RESPONSE TO ILLINOIS COMMERCE COMMISSION

DATA REQUEST NUMBER RAK-1.00

99-0488

Please provide a detailed breakdown of the \$358,920 for the water main extension to serve Windsor Parc.

RAK 1.05

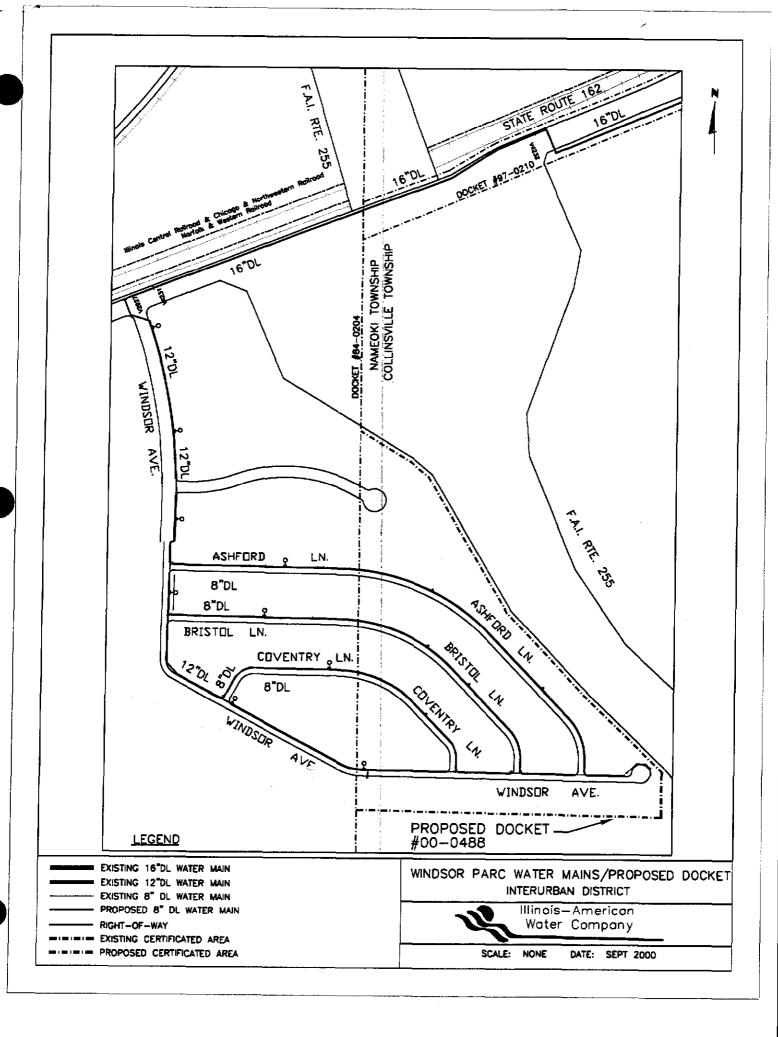
Please provide a detailed distribution map showing Illinois American Water Company's (IAWC) existing mains and the proposed distribution main to serve

the mobile home park and 10 commercial lots.

See attached.
